Final Drainage Report
for
Rolling Hills Ranch Filing 3
at
Meridian Ranch

PCD Project No. SF-21-016

Drainage Report - Final_V2_Comments.pdf Markup Summary

ROLLING HILL RANCH FILING 3 MERIDIAN RANCH

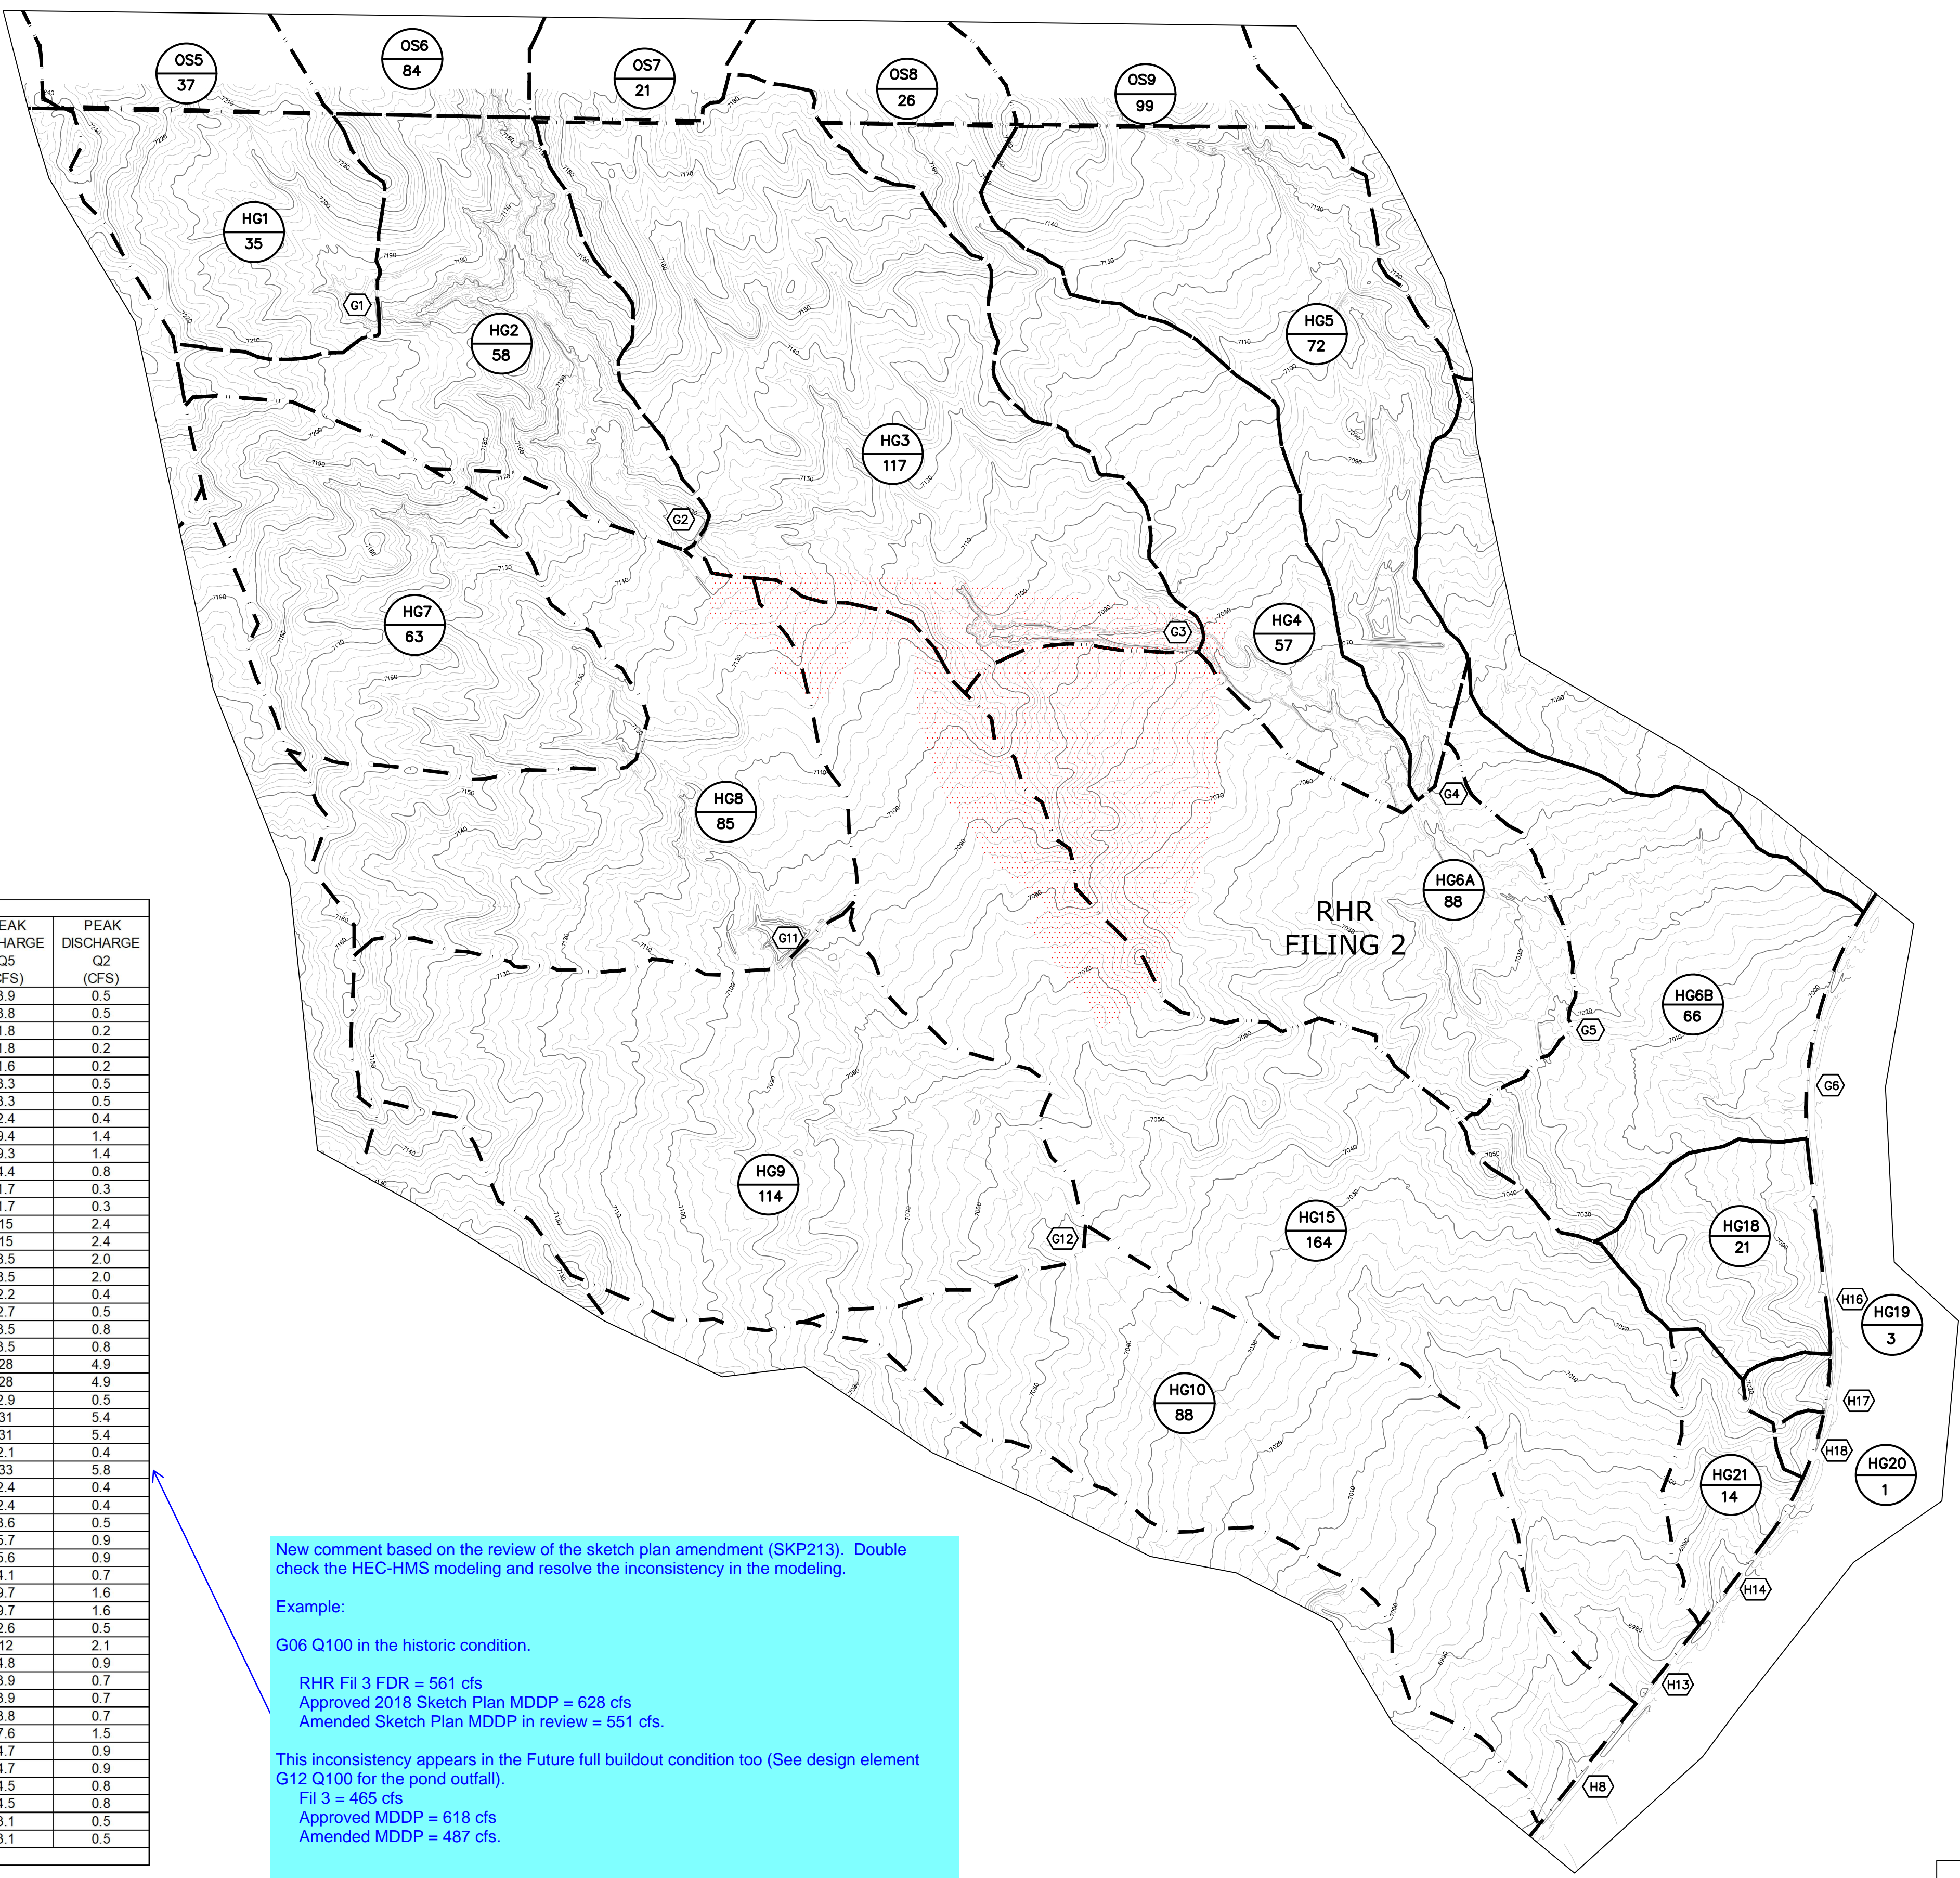
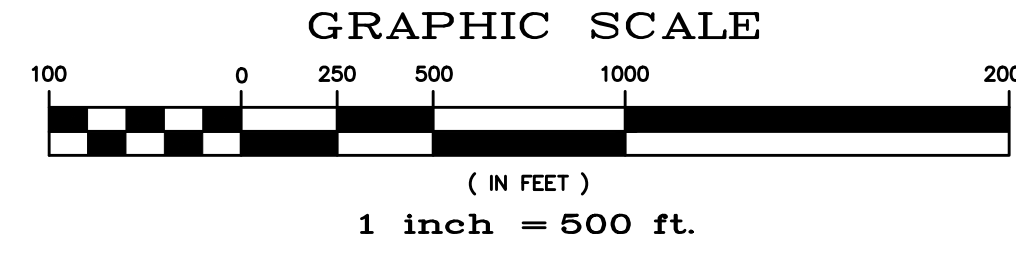
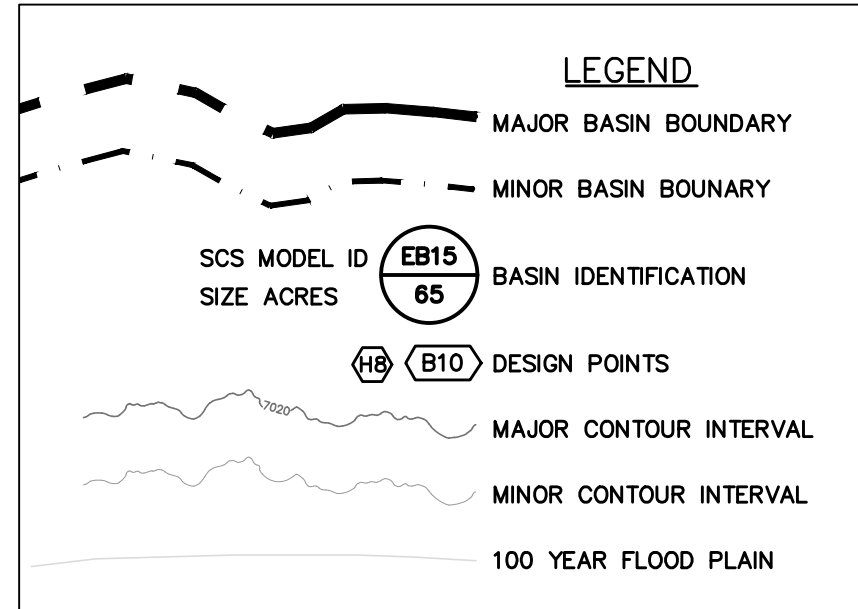
New comment based on the review of the sketch plan amendment (SKP213). Double check the HEC-HMS modeling and resolve the inconsistency in the modeling.

Example:

RHR Fil 3 FDR = 561 cfs
Approved 2018 Sketch Plan MDDP = 628 cfs
Amended Sketch Plan MDDP in review = 551 cfs.
